**CHARLOTTE DOUGLAS INTERNATIONAL AIRPORT  
CHARLOTTE, NORTH CAROLINA**

**ADDENDUM NO. 2**

**NORTH END AROUND TAXIWAY (NEAT)  
OVERLOOK RELOCATION**

**CLT PROJECT NO. AVIA 23-50  
ADDENDUM DATE: MAY 25, 2023**

SHT.  
**X-1**

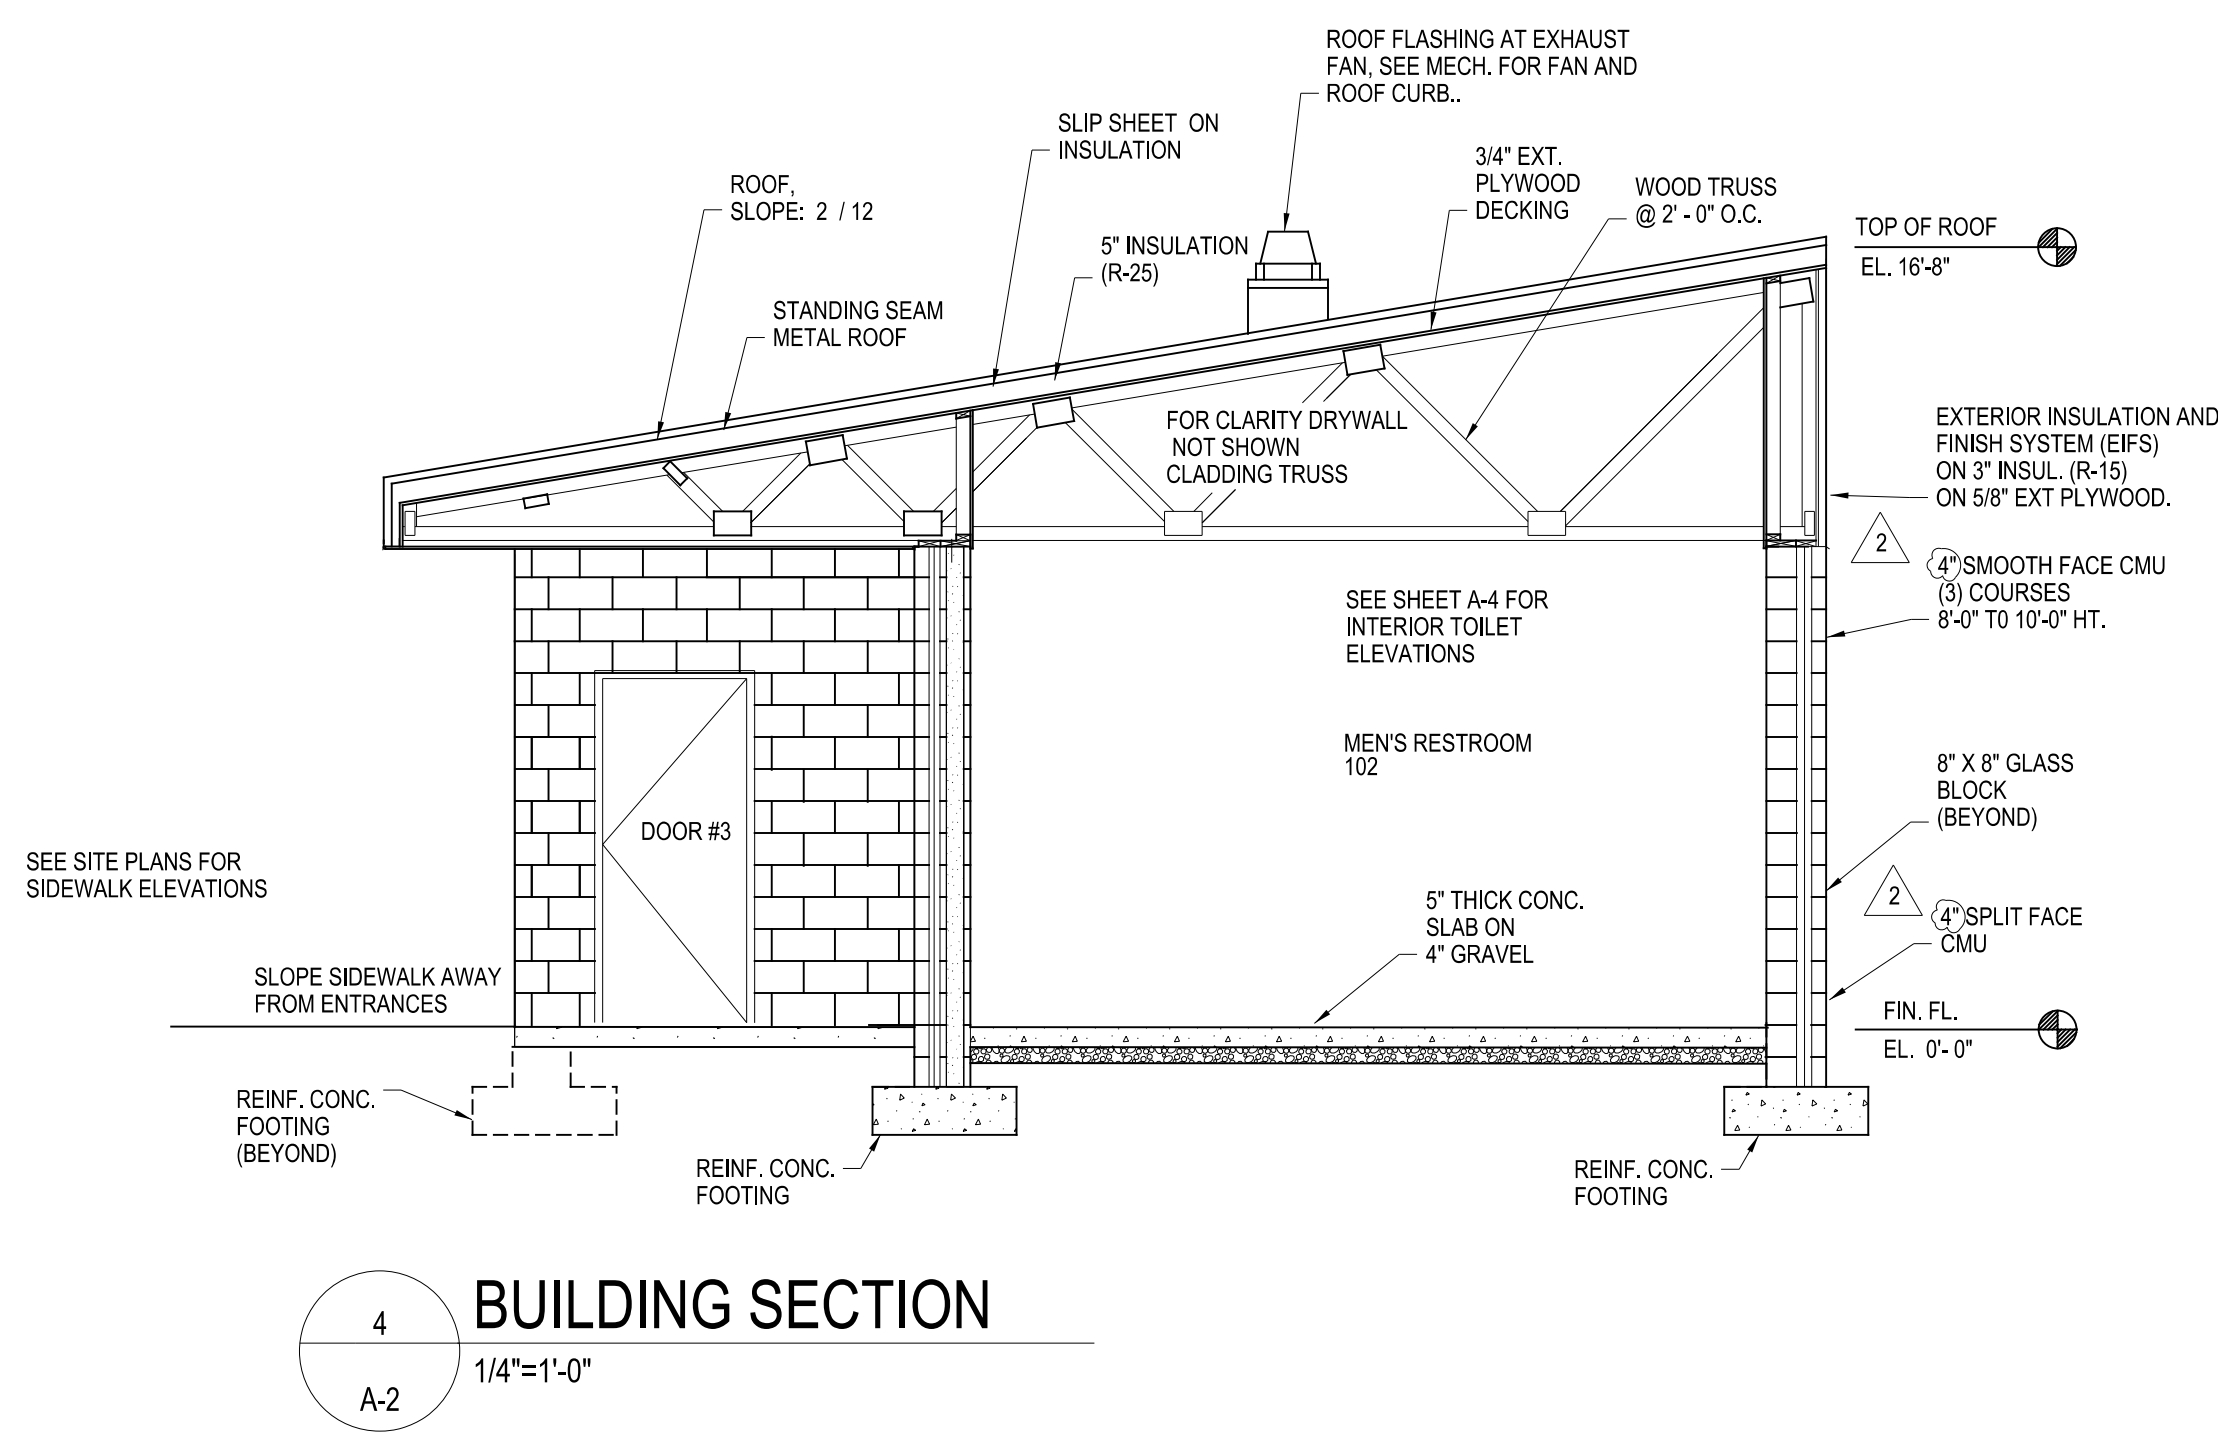
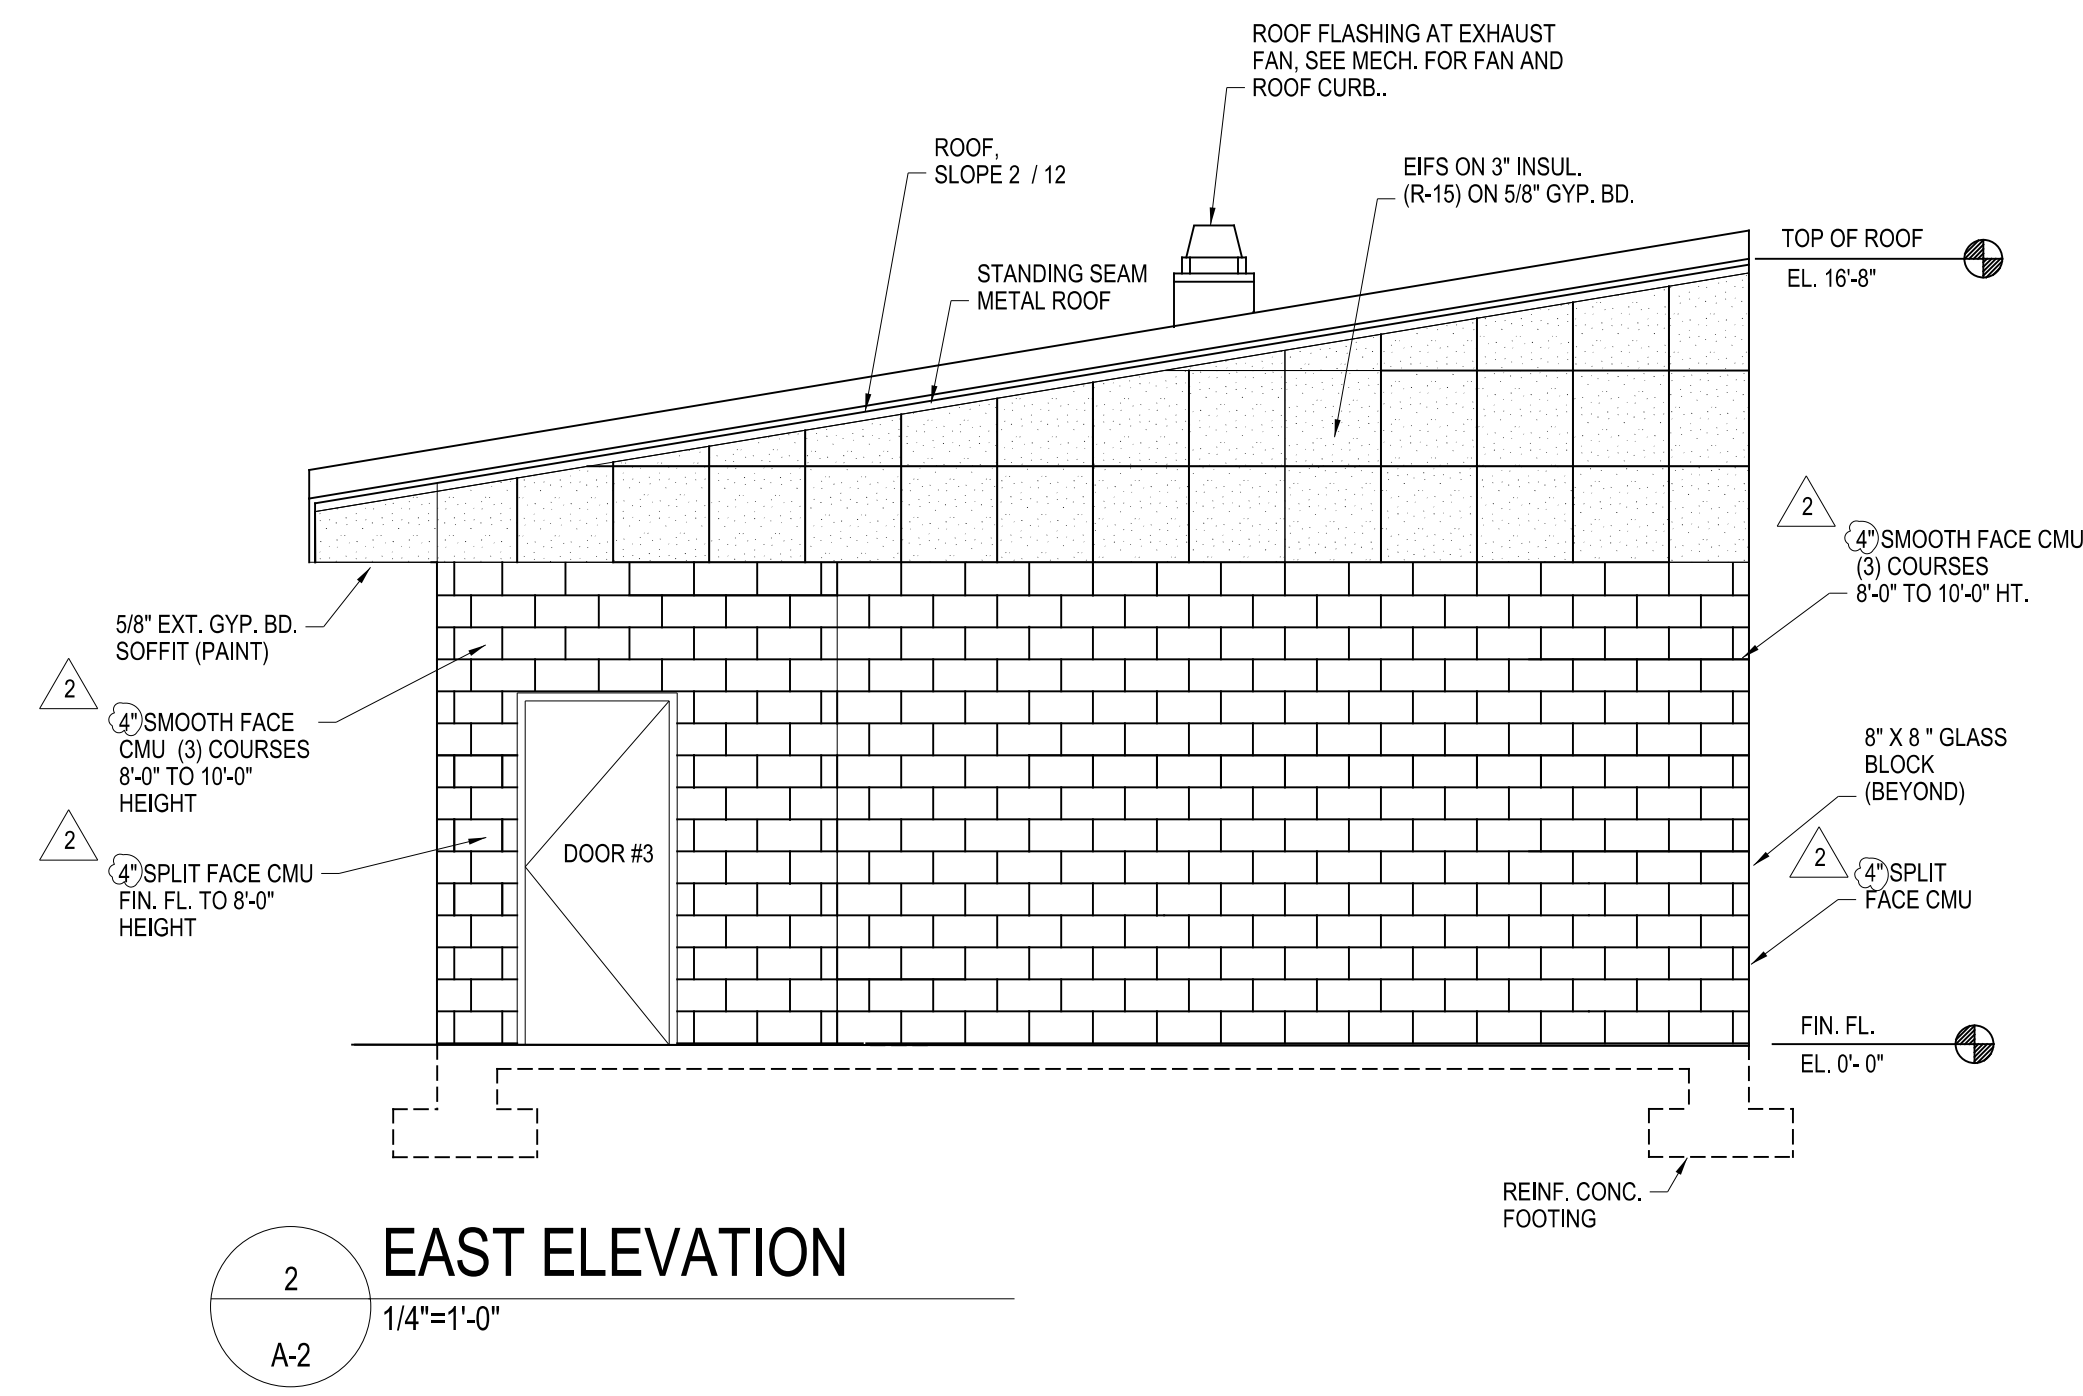
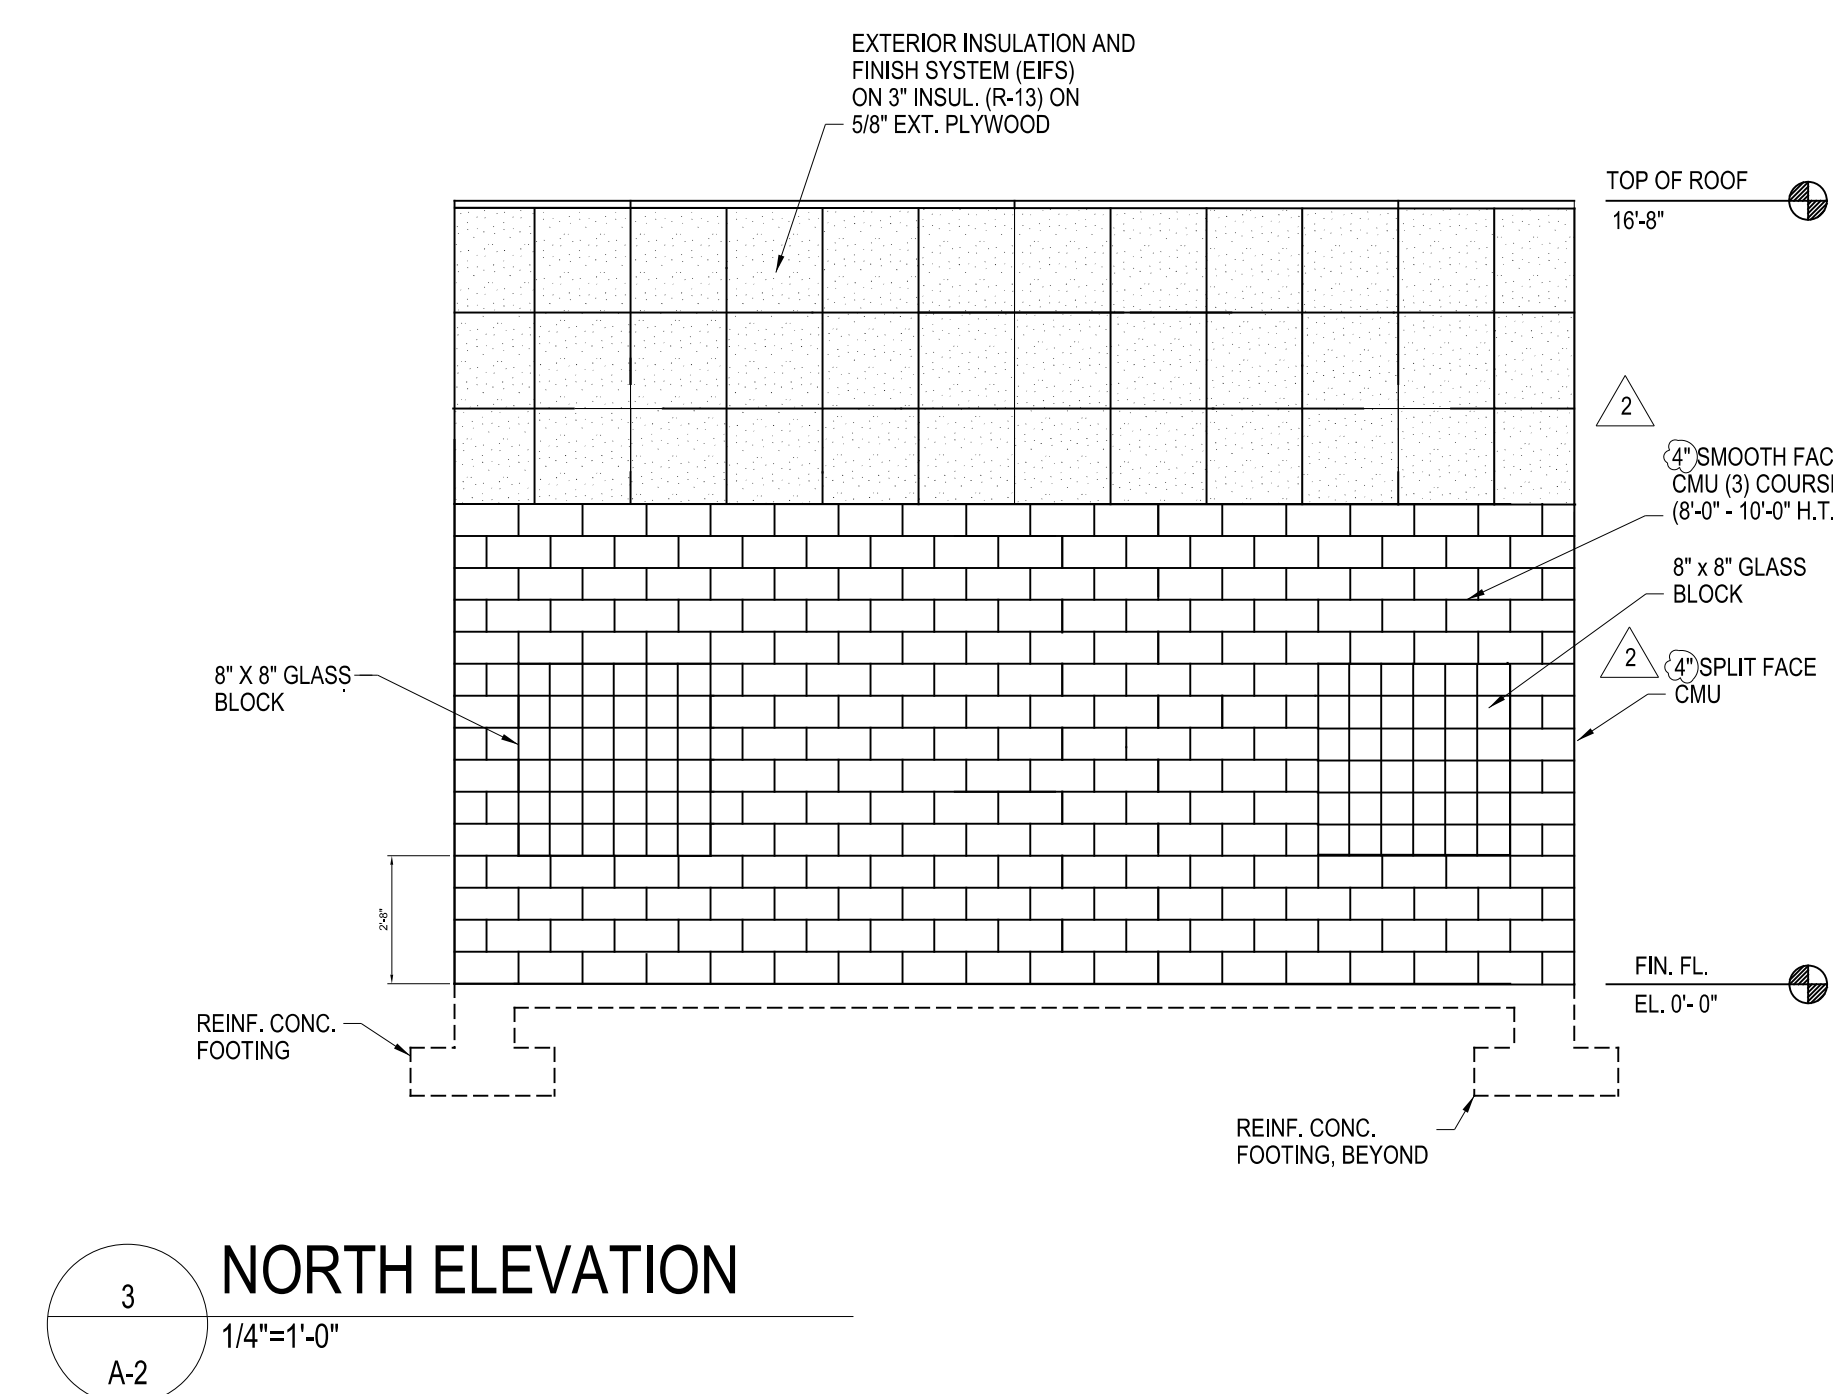
REVISIONS		DATE
1	ADDENDUM NO. 2 - REVISED EARTHWORK NOTE	05/25/2023
2		
3		
4		
5

NOTE: QUANTITIES ARE APPROXIMATE ONLY. THE CONTRACTOR WILL PROVIDE THE RESIDENT PROJECT REPRESENTATIVE AN INITIAL SURVEY PRIOR TO BEGINNING WORK AND A FINAL SURVEY TO BE USED TO COMPUTE THE FINAL QUANTITIES FOR WHICH THE CONTRACTOR WILL BE PAID. THE INITIAL SURVEY, FINAL SURVEY AND QUANTITY CALCULATIONS ARE INCIDENTAL TO UNCLASSIFIED EXCAVATION.
